COMMUNITY PLANNING DEPARTMENT
STAFF REPORT AND RECOMMENDATION TO
THE HEARING EXAMINER
FILE No: SUB-2022-0022

Staff Report Date:	April 3, 2023
Public Hearing Date and Location:	April 10, 2023, Hybrid Hearing
Report Prepared By:	Steve Donovan, AICP, Planning Manager
Report Reviewed By:	Anthony Muai, AICP, Community Planning Director
Summary Recommendation:	The City of Kennewick RECOMMENDS APPROVAL with conditions of Preliminary Plat SUB-2022-0022.
Summary of Proposal:	A Preliminary Plat proposed to subdivide 49.74 acres into 125 lots and 9 tracts.
Proposal Location:	7165 W 32 nd Avenue, 7082 W 34 th Avenue, 7117 W 30 th Avenue, Parcel Numbers 1-1789-204-0005-001, 1-1789-200-0001-017 and 1-1789-200-0001-014
Legal Description:	See Exhibit 3
Property Owner(s):	Tri-Cities Development, LLC Attn: Matt Smith 15 SW Colorado Avenue, Unit 1 Bend, OR 97702
Applicant:	PBS Engineering and Environmental Attn: Jason Mattox, PE 400 Bradley Boulevard, Suite 106 Richland, WA 99352
Engineer:	Same As Above
Surveyor:	PBS Engineering and Environmental Attn: Alex Matarazzo, PLS 200 Bradley Boulevard, Suite 106 Richland, WA 99352

The proposed Preliminary Plat (SUB-2022-0022) is a request for the subdivisi

COMPREHENSIVE UTILITY PLAN FOR:

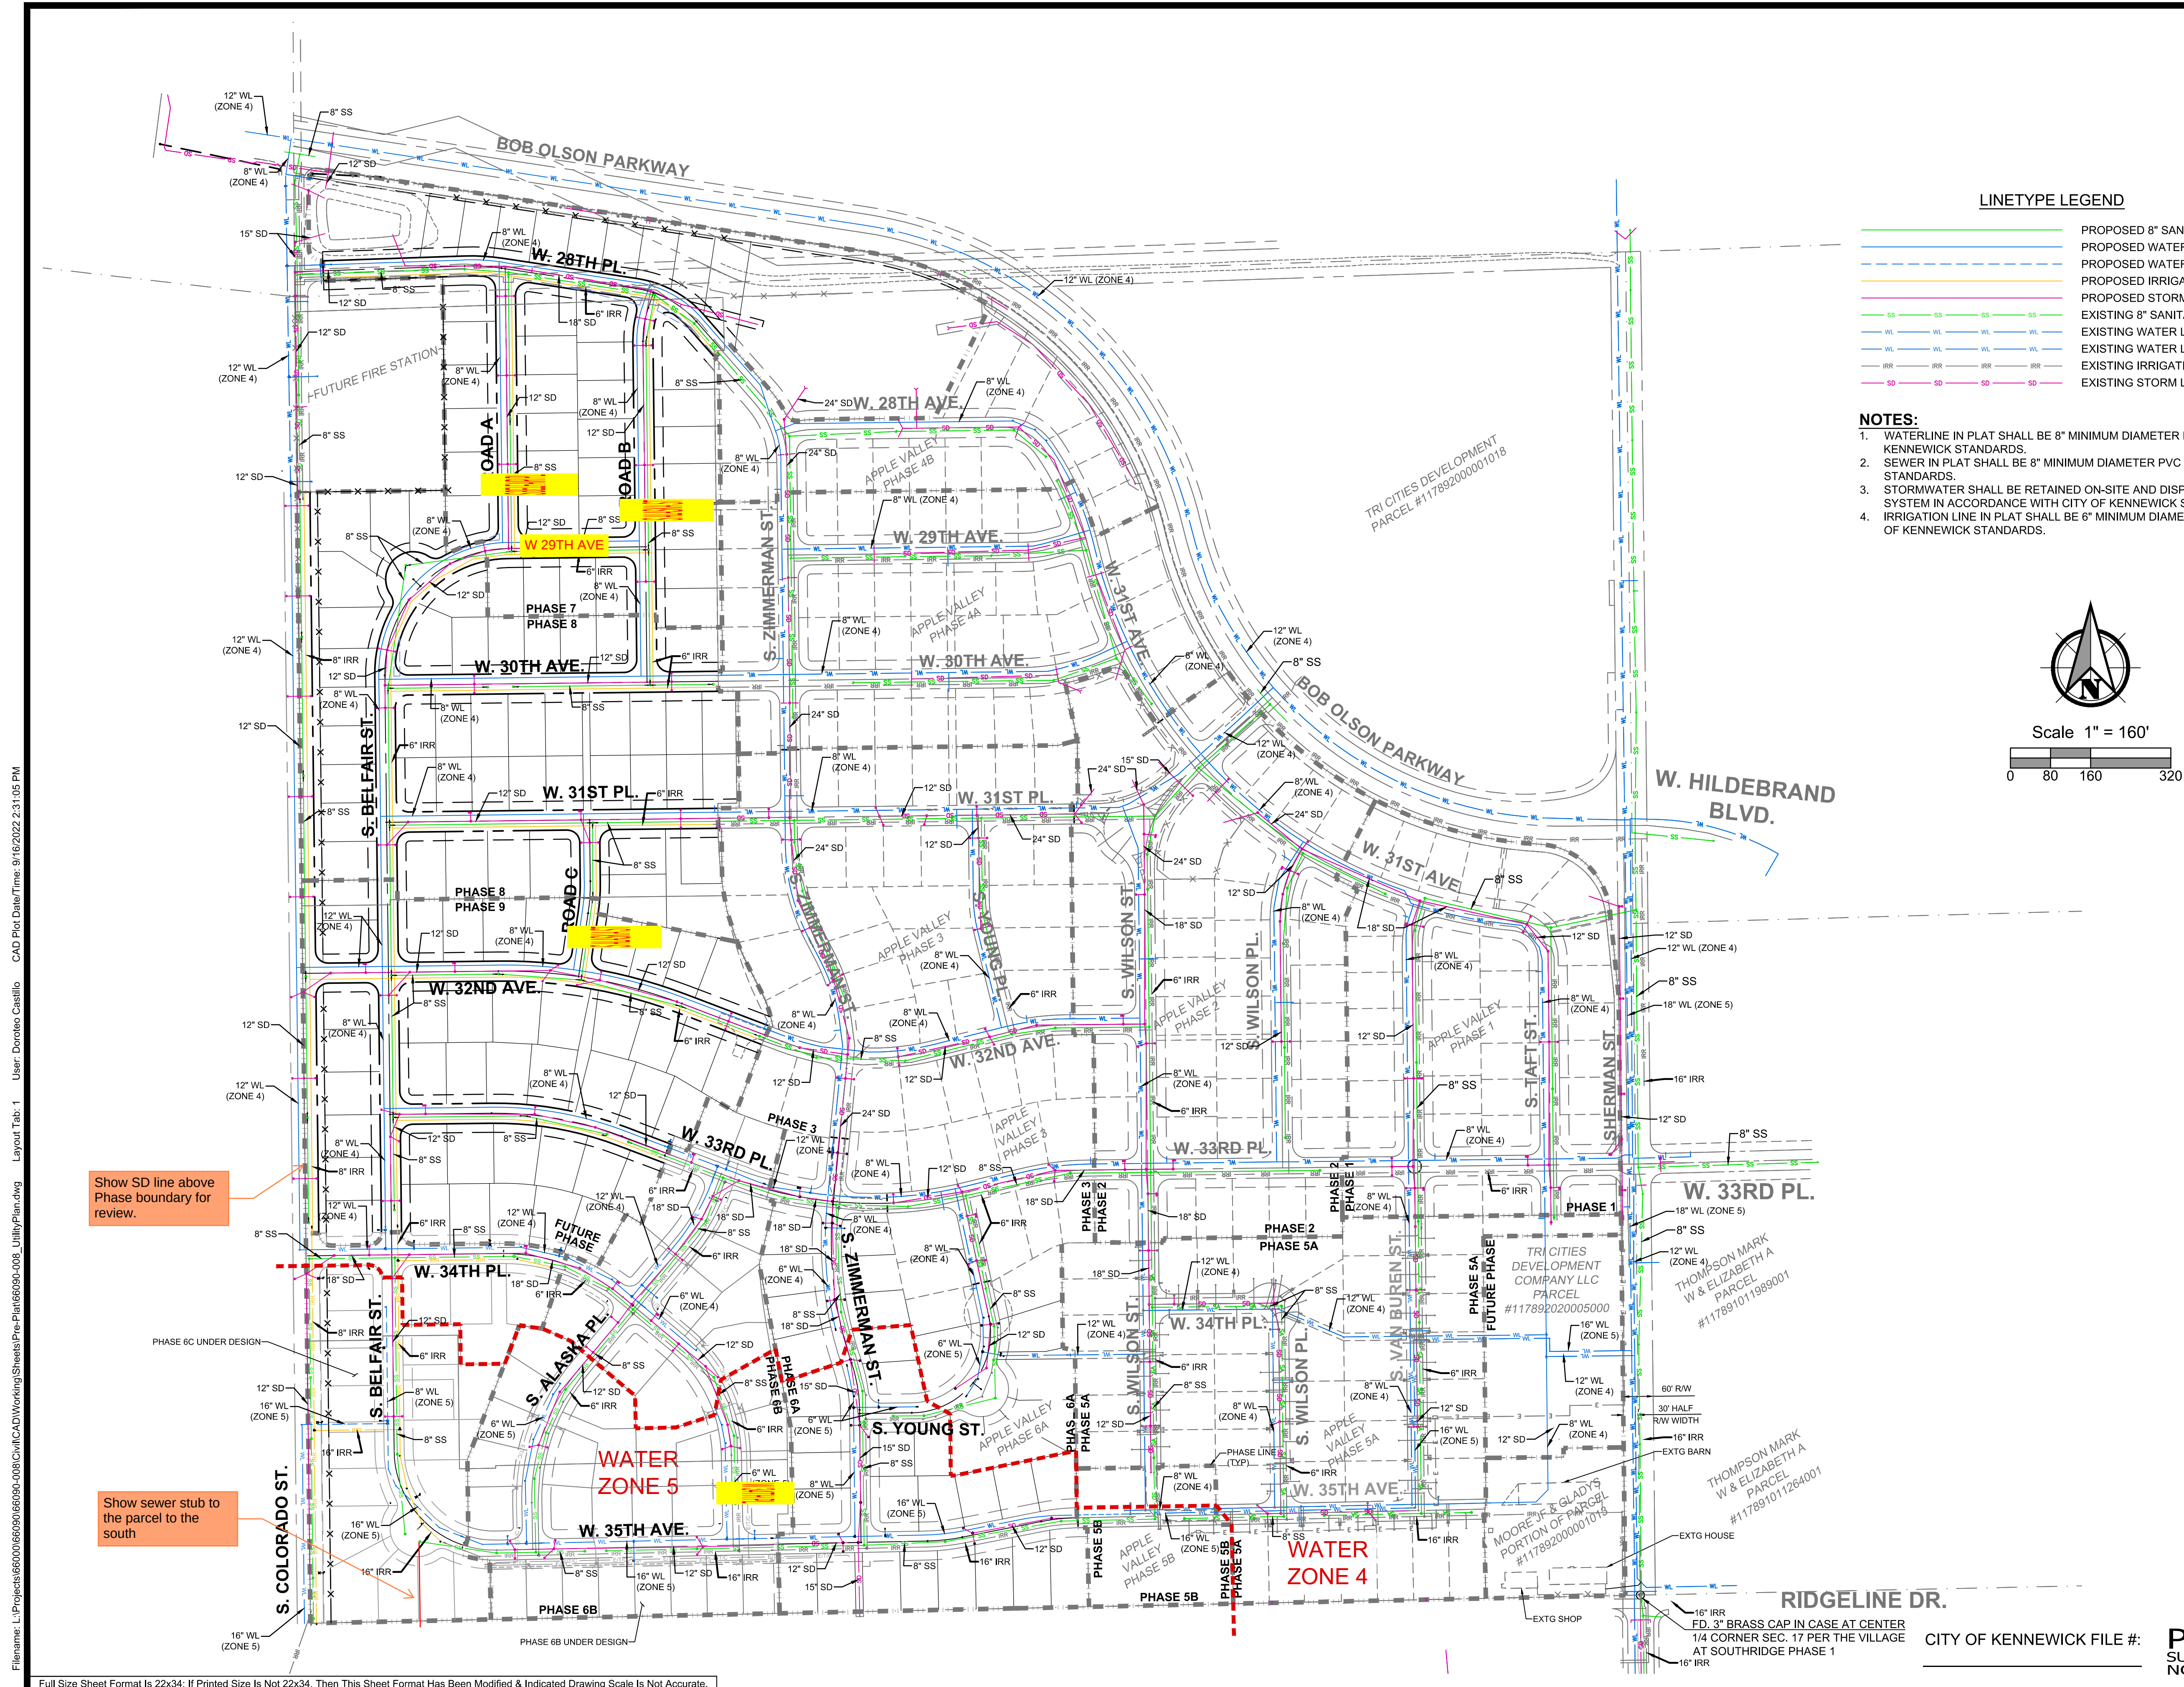
3. Developer will be required to provide construction of private roads, sidewalks, streetlights, storm drainage, and designate sidewalk and utility easements, all in conformance with the latest City of Kennewick (COK) Standard Specifications and Details.

4. The maximum street grade per KMC 5.56.275 is 12%. Show grades on the street centerline profile.
5. Buildings or structures may not be located over City utilities.

6. Provide water and sanitary sewer services for each proposed dwelling or building per Kennewick Municipal Code KMC 14.13.020, 14.22.020(1), KMC 17.13.095(1), KMC 17.12.055 and fire flow as required by the Fire Department.

7. Water and sewer services to be constructed per City of Kennewick (COK) Detail 3-6.
8. Streets adjacent to this project have a Pavement Condition Index (PCI) rating equal to or above 75, therefore trenching will not be allowed per KMC 5.56.215 unless specified exceptions have been met. Any trenching done on pavement with a PCI rating of 75 or over will require a minimum 25-foot wide patch and full width of each travel lane or shoulder disturbed.

9. Provide 15-foot wide easements or tracts centered over all water mains outside of the right-of-way. These easements must extend to 5 feet behind fire hydrants.

10. The Developer shall provide and install one metered water service for each proposed dwelling or building at their own expense per COK Standard Detail 3-6. The meter shall be placed as close to the main line as possible (not in a driveway or parking area) per KMC 14.12.080.

11. All proposed water main extensions must conform to the adopted City master plan, as amended and must conform to an overall program for a grid system, with provisions made for extensions of looping for circulation where at all possible per KMC 14.10.030.

12. Provide water lines and hydrants as required by Fire Department to meet fire protection.

16. Provide 15-foot wide easements or tracts centered over all sewer mains outside of the right-of-way.
17. All proposed sanitary sewer extensions will be required at Developer expense. On the Plans, provide a Sewer Comprehensive Plan for the site/subdivision meeting KMC 14.22.040.

18. Provide a Storm Water Site Plan (drainage report) and storm design to retain and dispose of a 25-year 24-hour storm following the Storm Water Management Manual for Eastern Washington (SMMEW) and Section 5-8. Infiltration tests are required at the location and depth of the planned infiltration structures along with a soils log to 5 feet below that point. Design and construct all underground infiltration structures to meet the Washington State Underground Injection Control (UIC) Rule. Provide an assessment of the design against the UIC pretreatment requirements found in section 5-6 of the SMMEW. Provide UIC registration numbers on the plans prior seeking the City's signature.

19. All plans showing existing utilities shall call out the Record Drawing set number that installed the utilities. All plans need to clearly identify the size and type of water/sewer utility that is being proposed or connected to (i.e. "Existing 8-inch Water" or similar). Label private lines "Private".

PRELIMINARY GRADING PLAN AND ROAD PROFILES FOR:
APPLE VALLEY - PHASES 7-9
A SUBDIVISION LOCATED IN THE CITY OF KENNEWICK, WASHINGTON

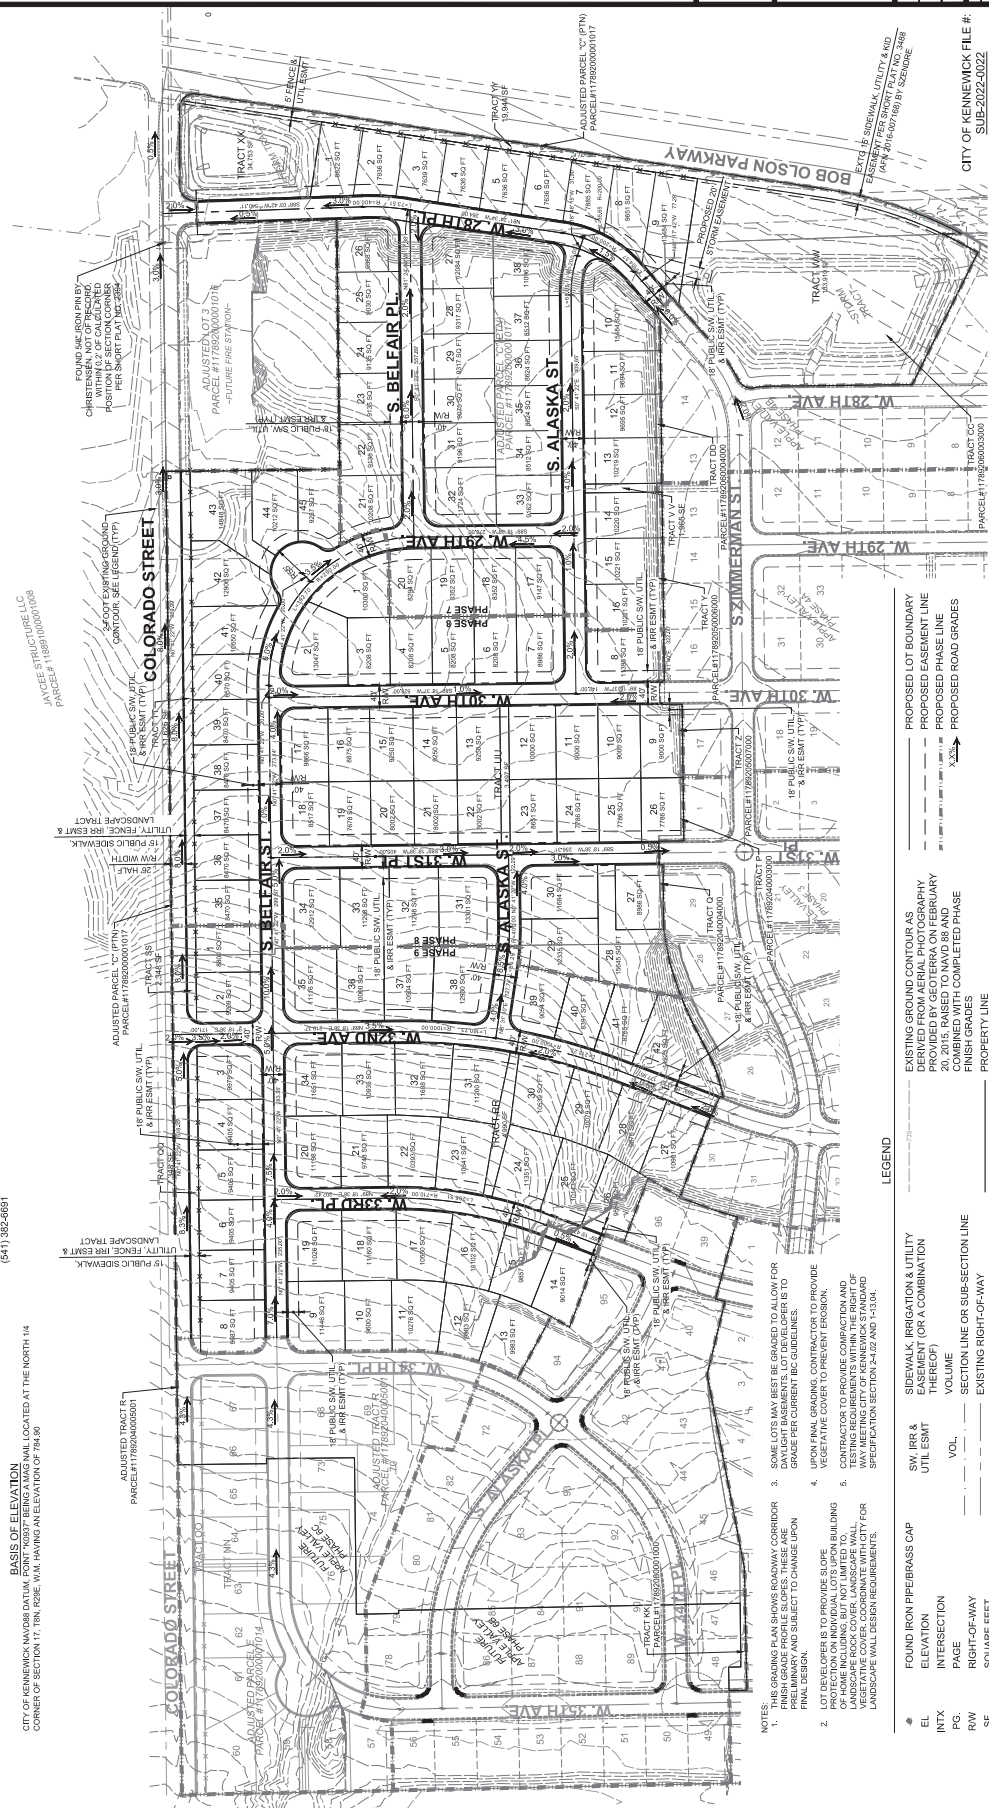
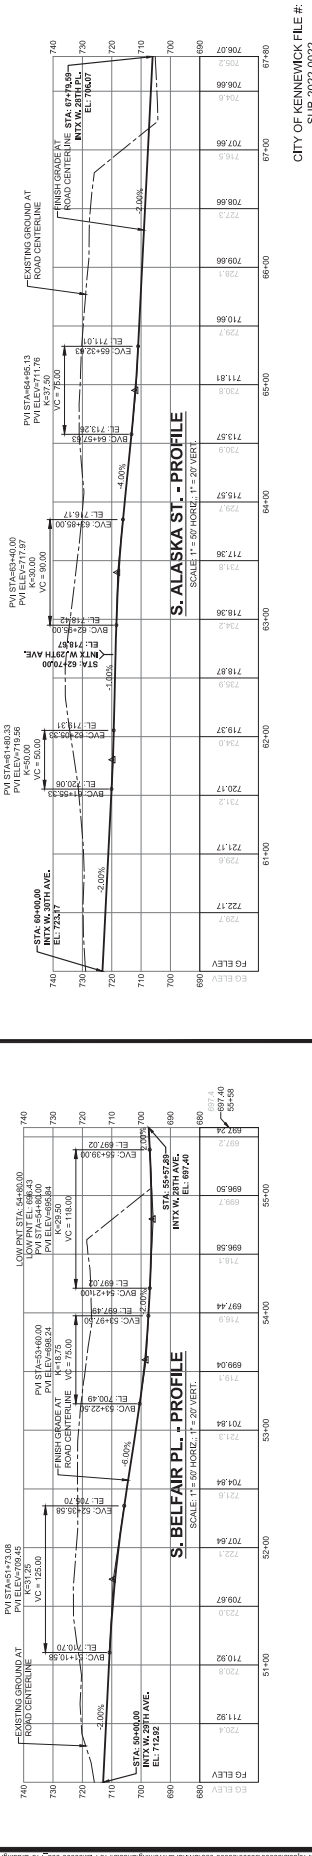
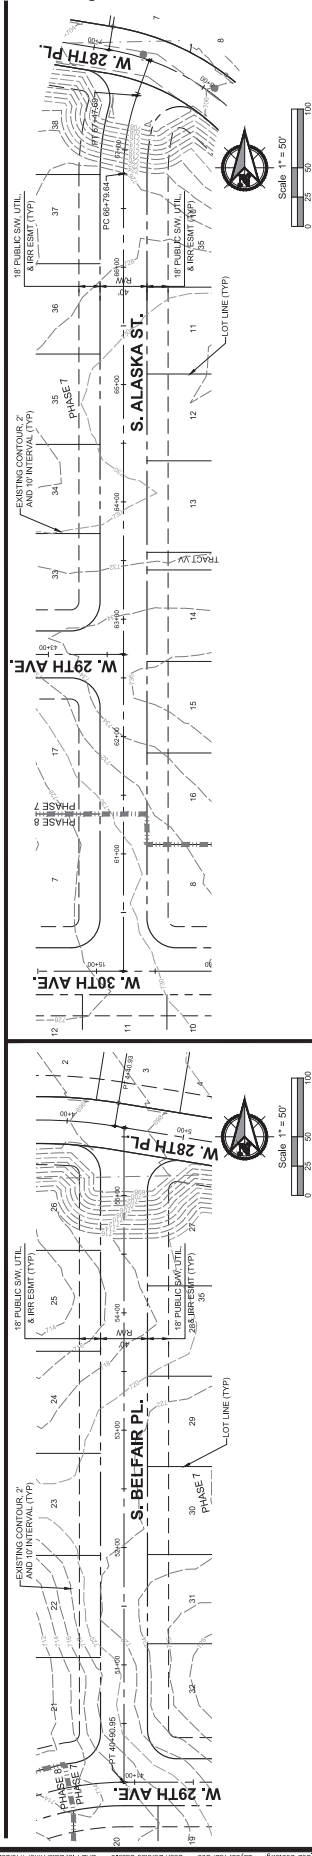
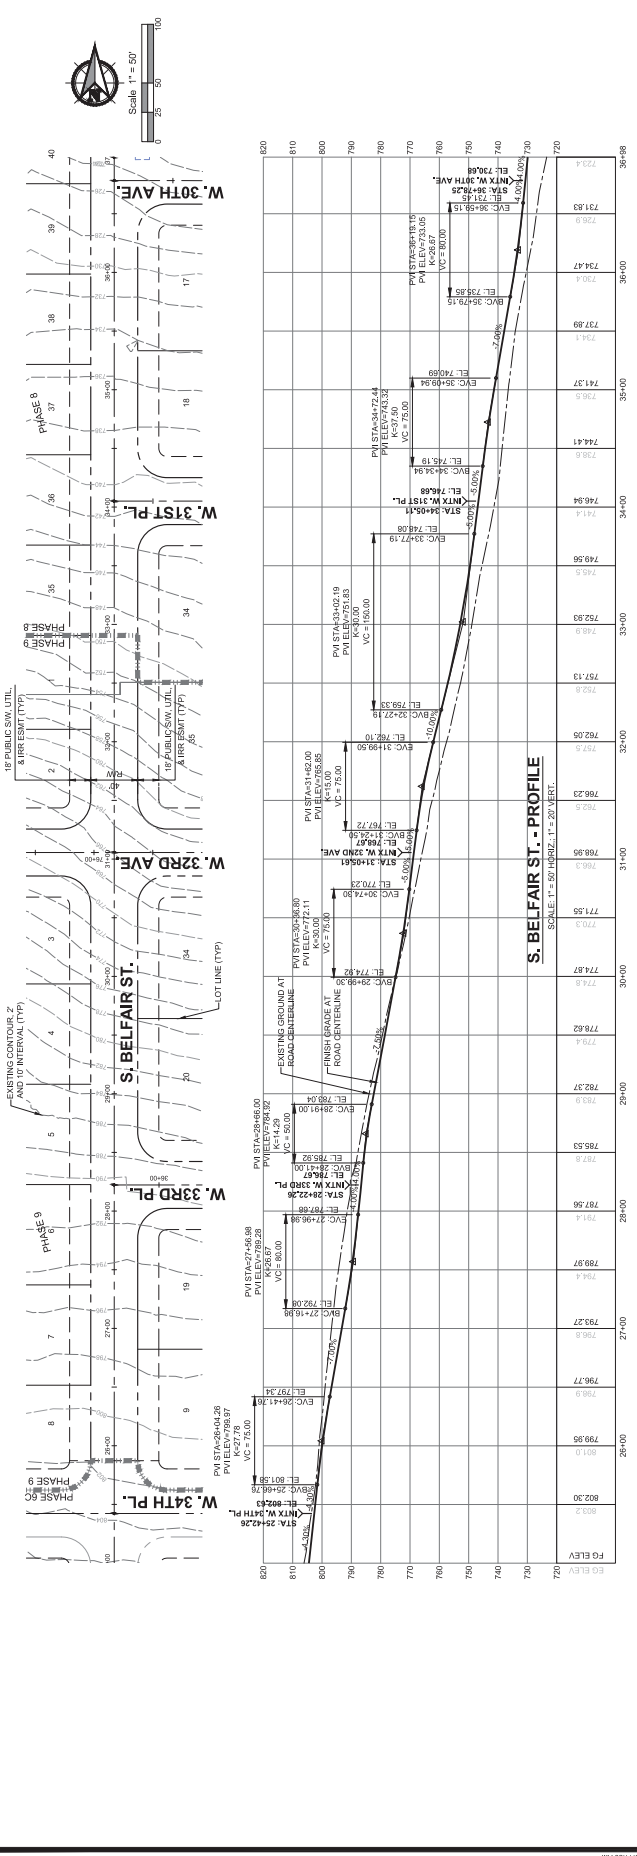
2. Sheet 2 comments:

- **Road name changes and updates from Sheet 1**
 - o Road name changes and updates from Sheet 1 have been completed
- **Eastbound right turn lane from Bob Olson Parkway to southbound S Colorado St. is required. Right turn lane’s construction to be completed and accepted by the City as a condition to Final Plat Approval**
 - o Comment has been received, and City’s position on this issue is understood. No additional analysis is required at this time.
